Planning Commission

TO: Planning Commissioners
FROM: Katie Peterson, AICP, Senior Planner
RE: Review of Revised Plans to COFA-03-23-017836
DATE: 10/25/2023
CC: Kevin Icard, AICP, Director of Growth Management

RE: Big Blue Marble Cypress Ridge – Planning Commission Comment Responses

1
A 101
NORTH ELEVATION
SCALE: 1/8"=1'-0"

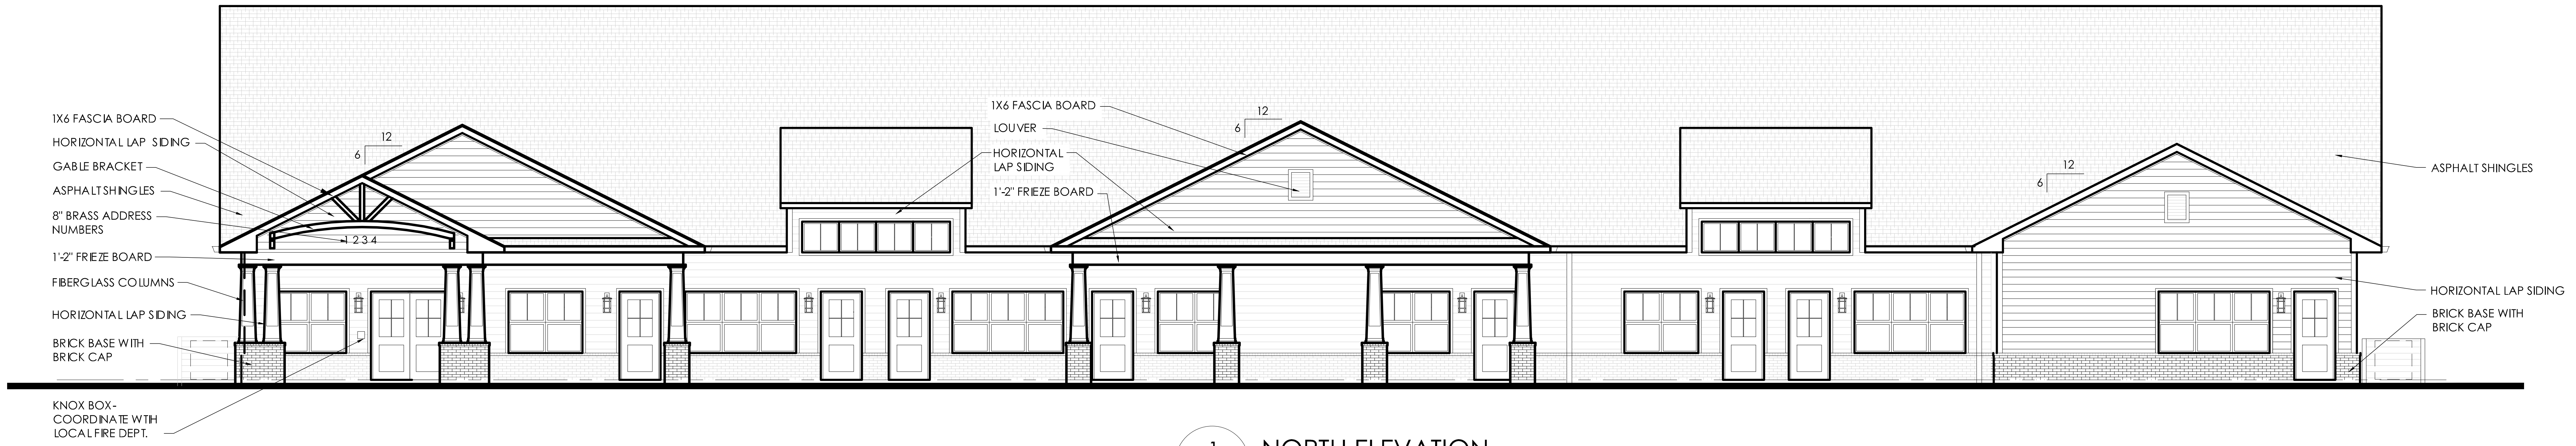
7. The shed roofs on the dormers were proposed at 3:12, which are required to be no less than 4:12. Options 2 and 3 address the roof pitches. Option one does not meet this requirement.
8. The columns, rather than the capitals, need to be aligned with the beam.
9. The intake on the front elevation must be below the roofline, including curbing and mechanicals, or moved to the side or rear elevation as it will not be approved should be visible from the front elevation once installed.
10. Consider increasing the height of the mechanical yards to ensure HVAC is concealed and electric meters are more concealed.
11. Move the three ridge vents on the roof to the rear elevation as they are not permitted on the front (HWY 170) elevation.

c. The shed roofs on the dormers should be increased to pitch 4:12.
      - Two (2) versions of the updated elevations have been provided with our resubmittal to allow the Planning Commissioners to select their preferred elevation.
      - One version depicts the 12:6 roof and 12:4 pitch of the dormers.
      - One version depicts the 12:5 roof and 12:3 pitch of the dormers.

DRAWING NUMBER A5302794-2	JOB 5302794 - Big Blue Marble Academy		
	SHIP DATE 1/31/2022	MODEL **K-A1-G10**

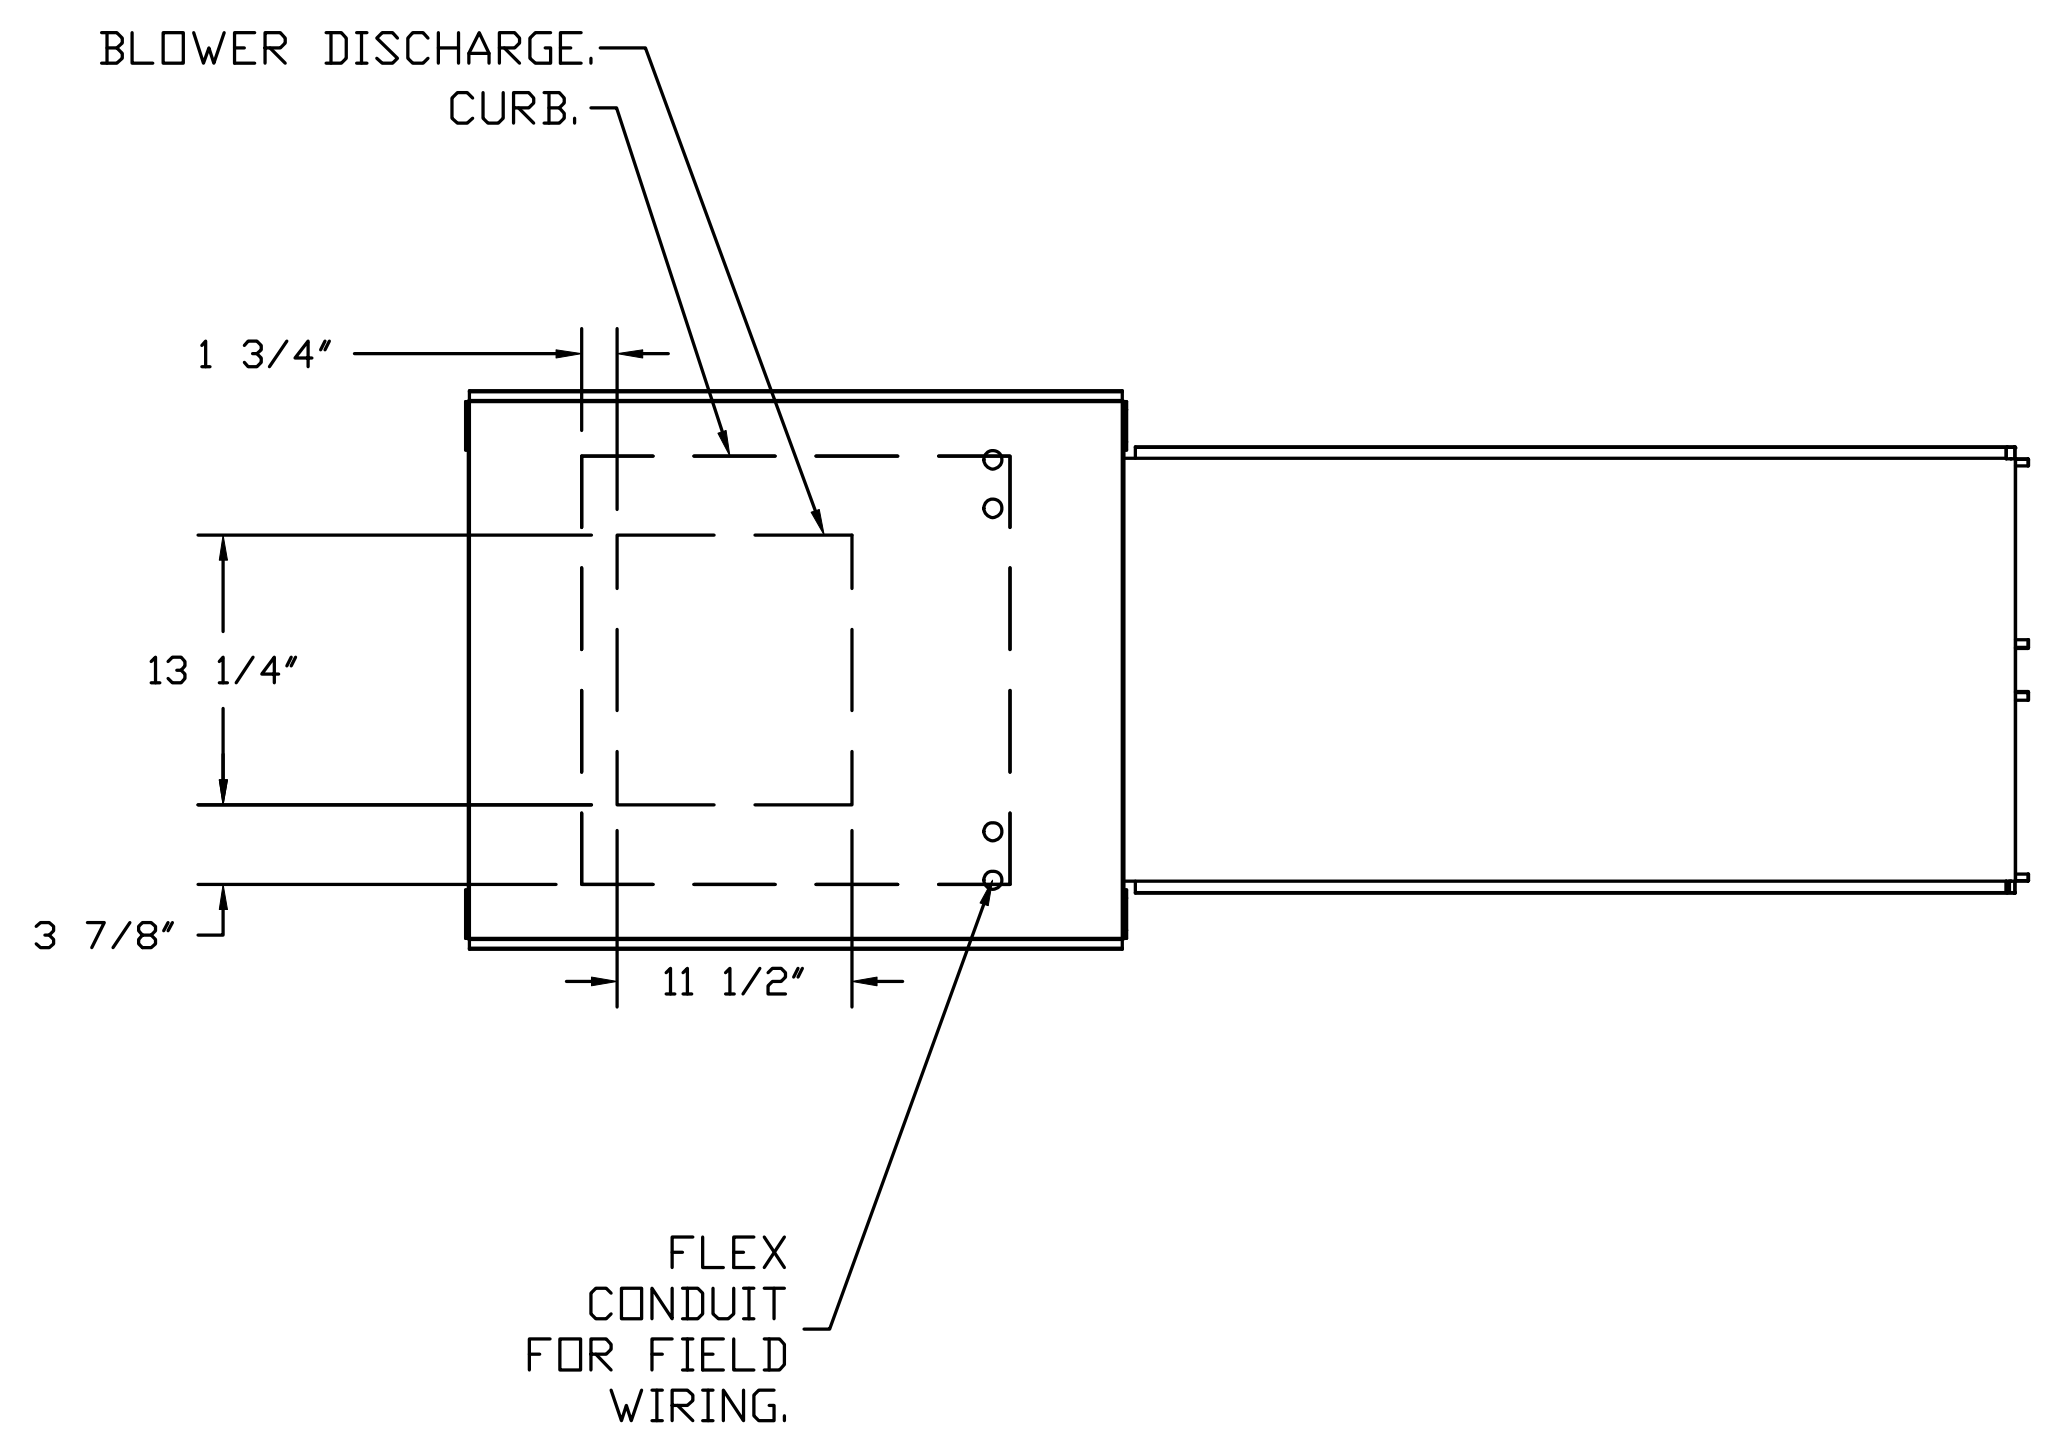
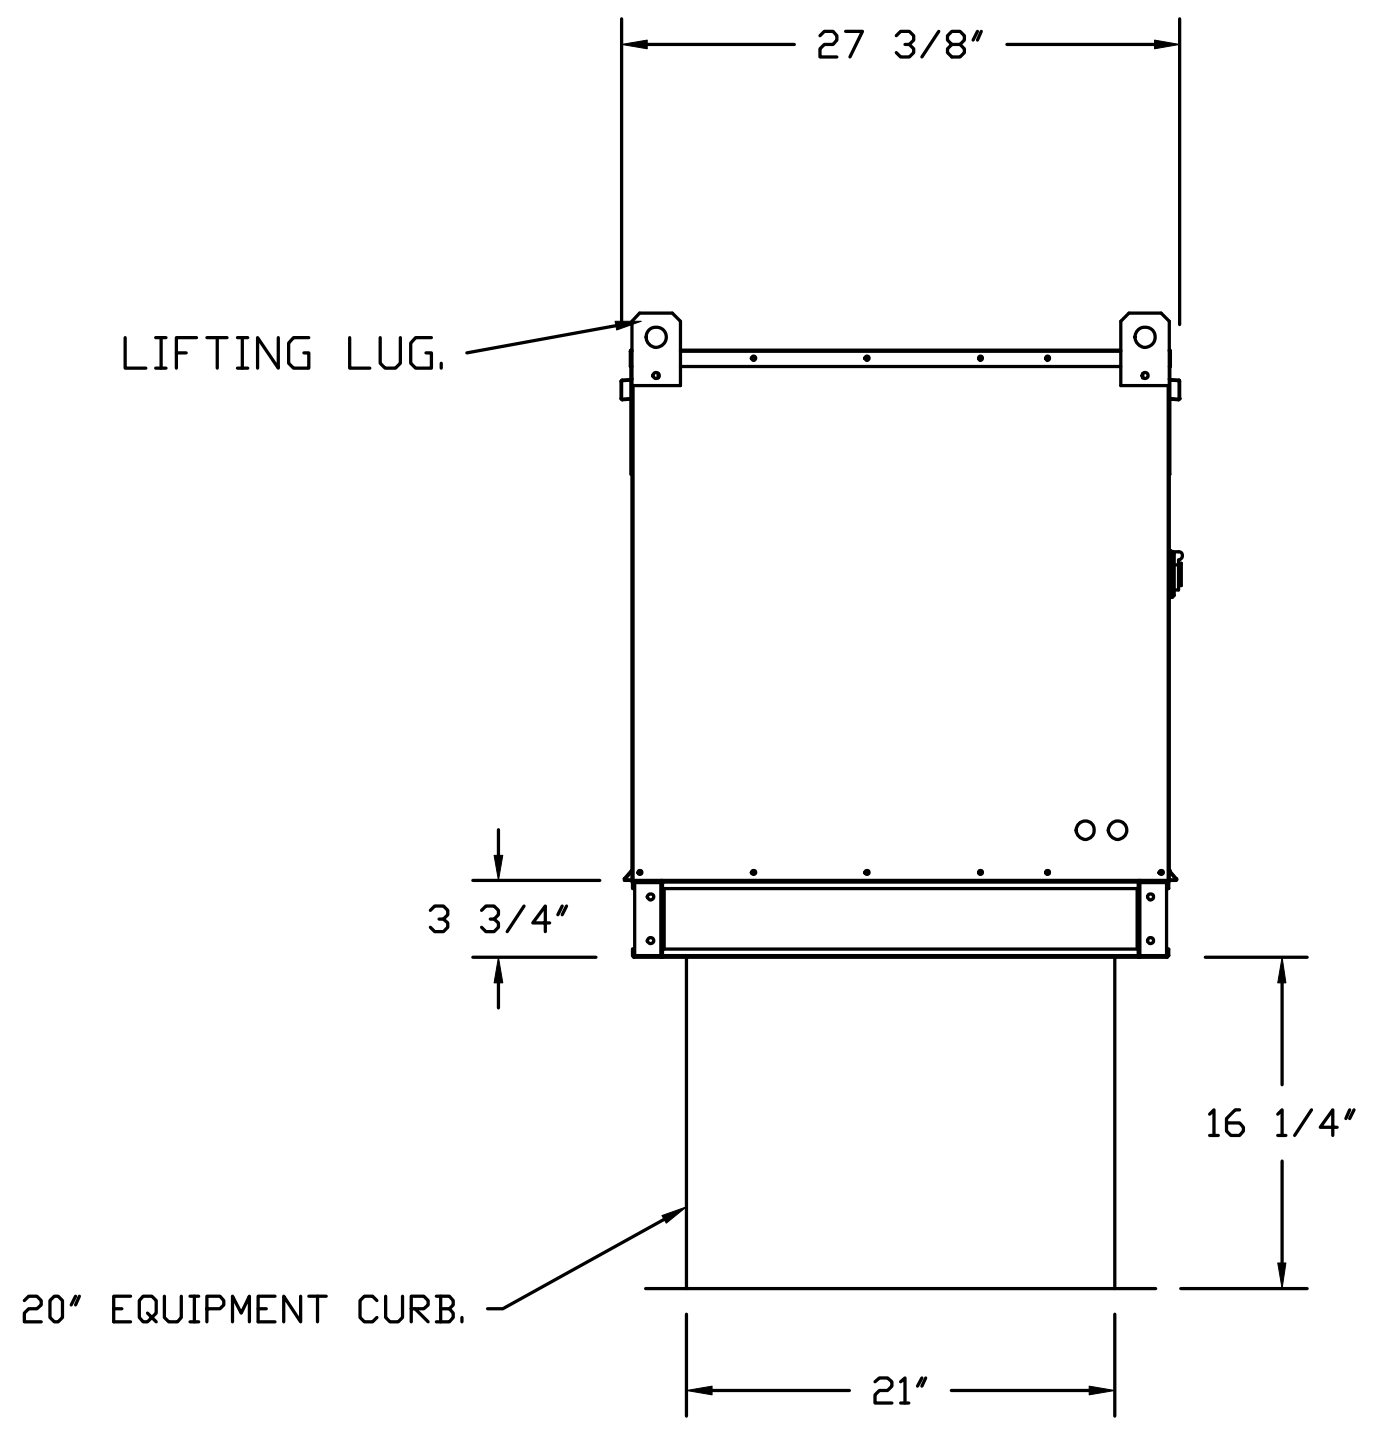
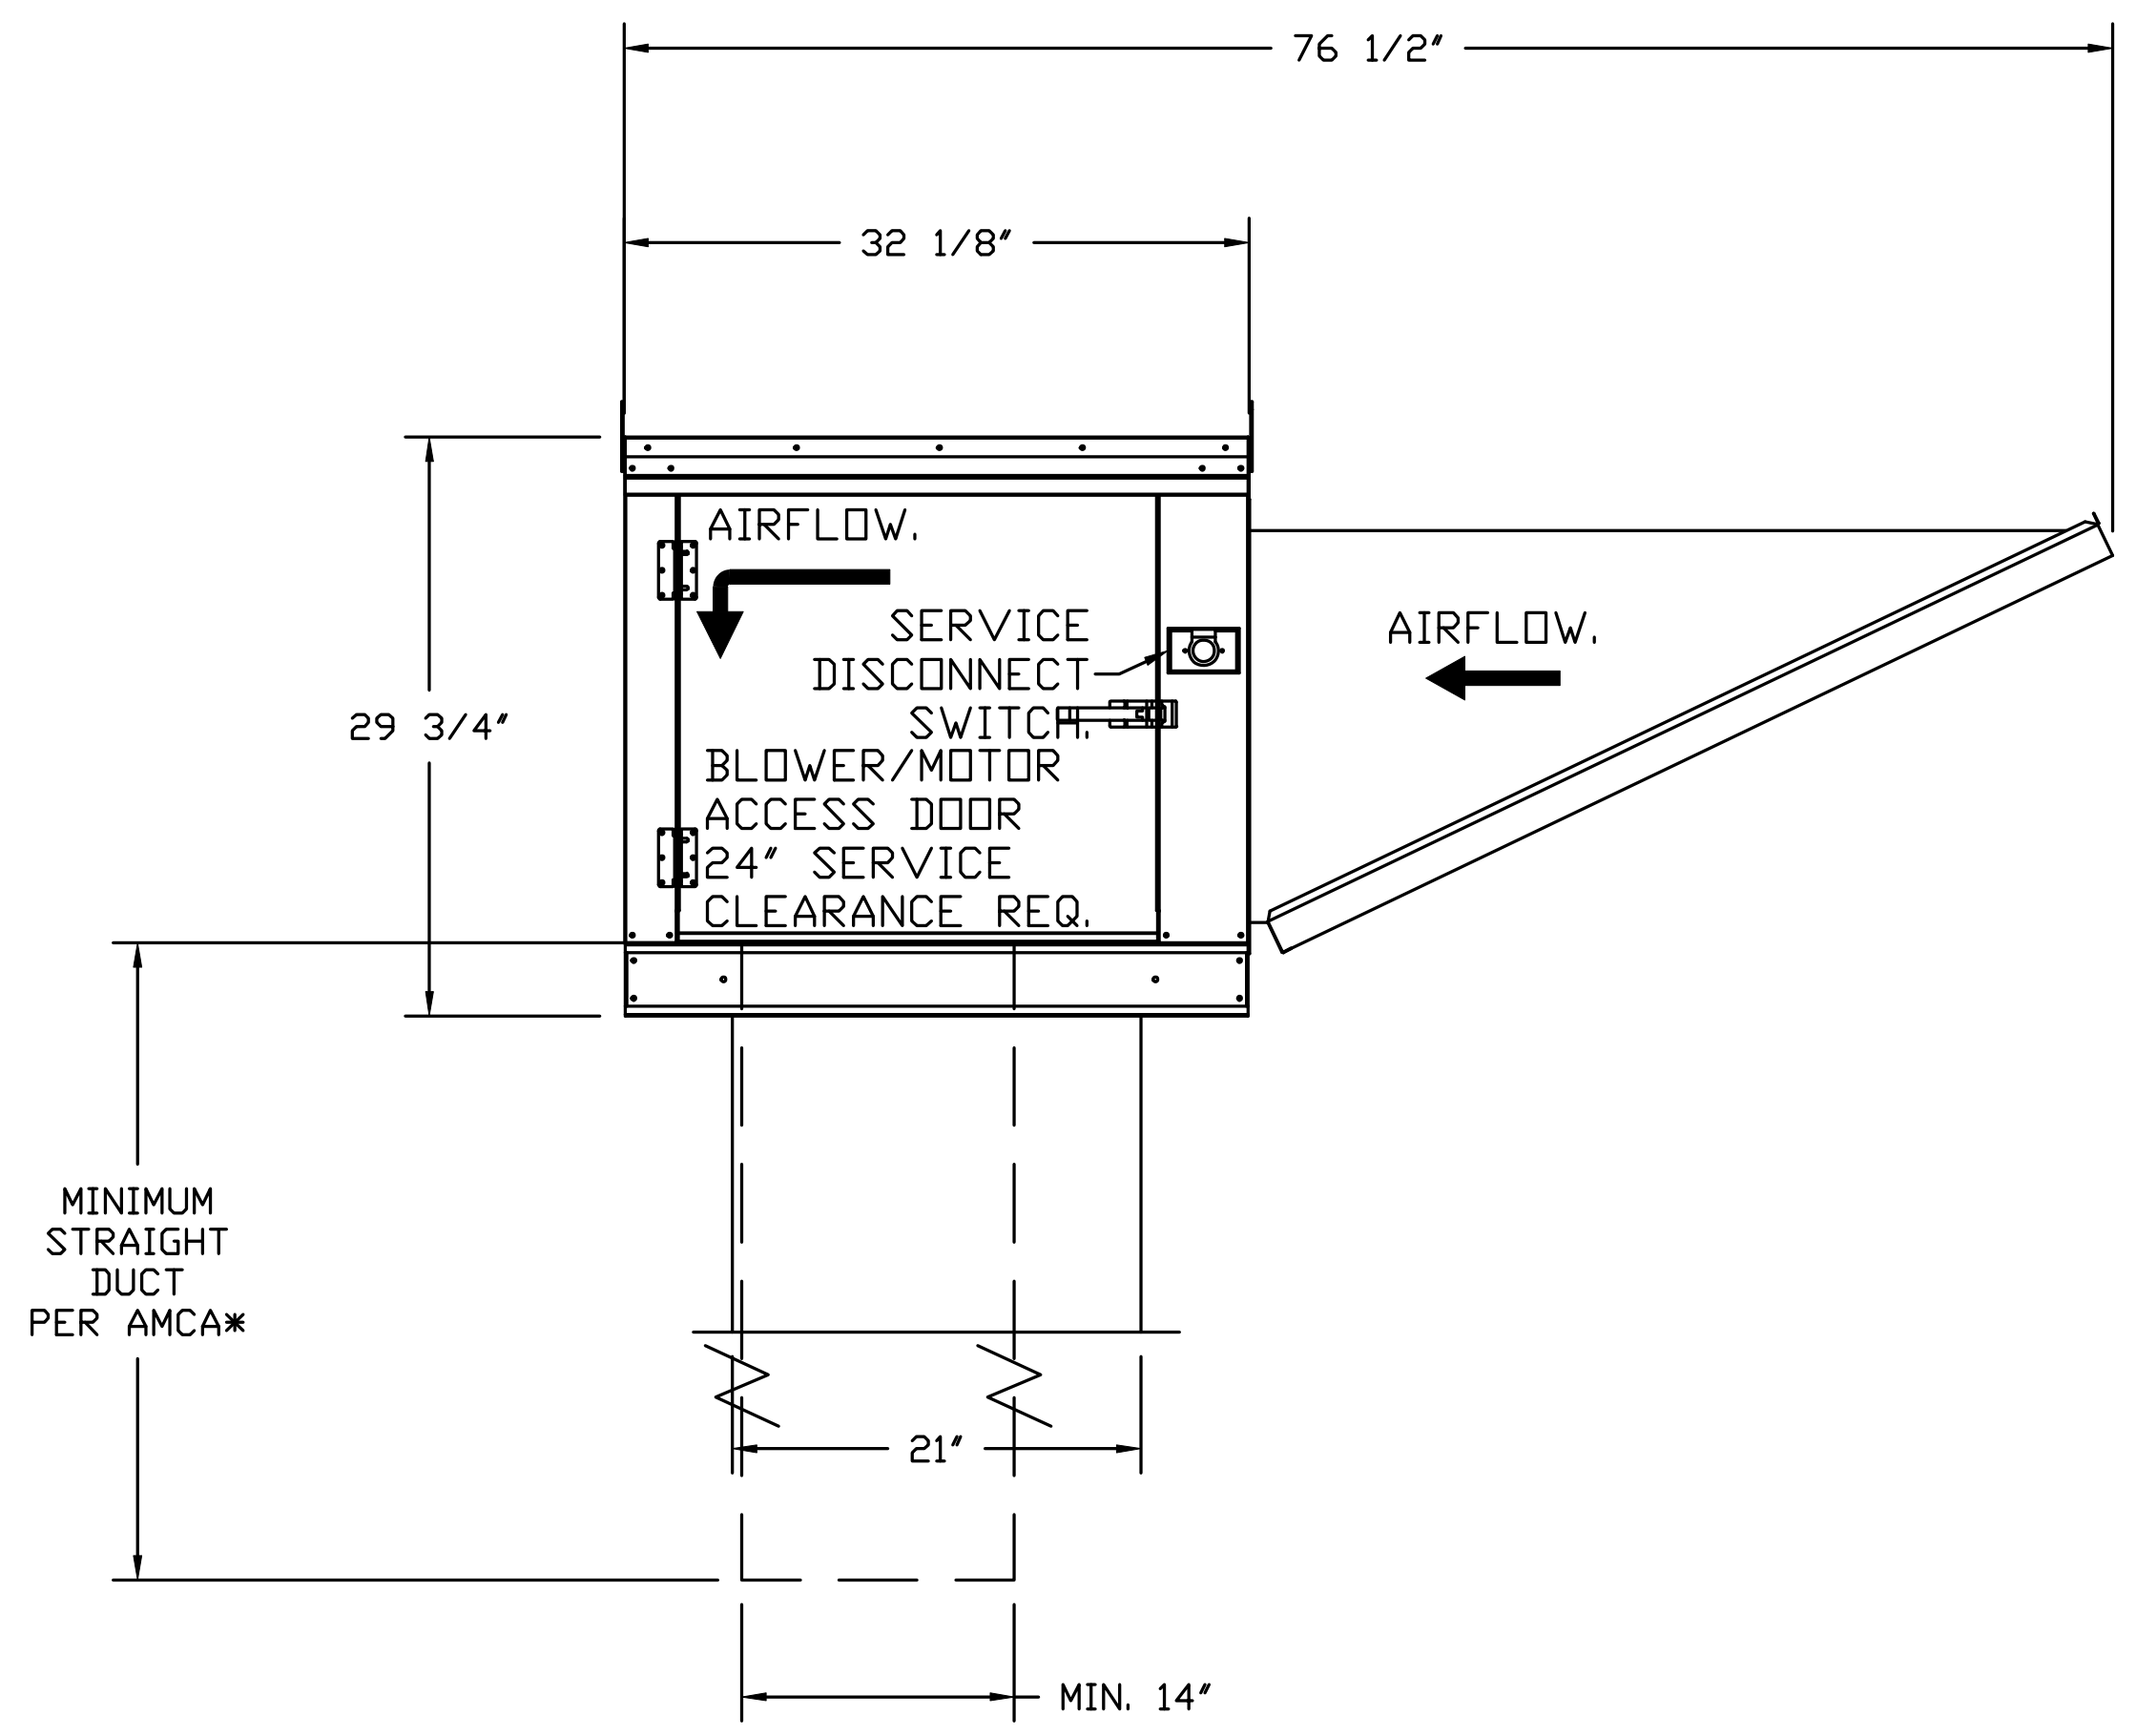
1. Per Section 4.16.2.A. all roof mechanicals are shown on the front elevation, facing Highway 170, and must be revised. While the hood system was shown as screened on the front elevation, building code requires the exhaust to be no less than 10 feet horizontally from parts of the same building, and the intake, if vented at an angle away from the wall(s). It could be 5 feet of clearance from the wall(s) if angled away, but still requires 10 feet of clearance from the intake. It was not able to be met in the space provided and needed to be redesigned.

1. **Architecture**
   a. Per Section 4.16.2.A. all roof mechanicals are shown on the front elevation, facing Highway 170, and must be revised.
      - The kitchen exhaust vent has been rerouted to outlet out the sidewell of the building, on the east elevation.
      - The rooftop mechanical unit has been inset into the roof line to provide screening from Highway 170. The specification sheet for the make-up air unit has been provided with this resubmittal.
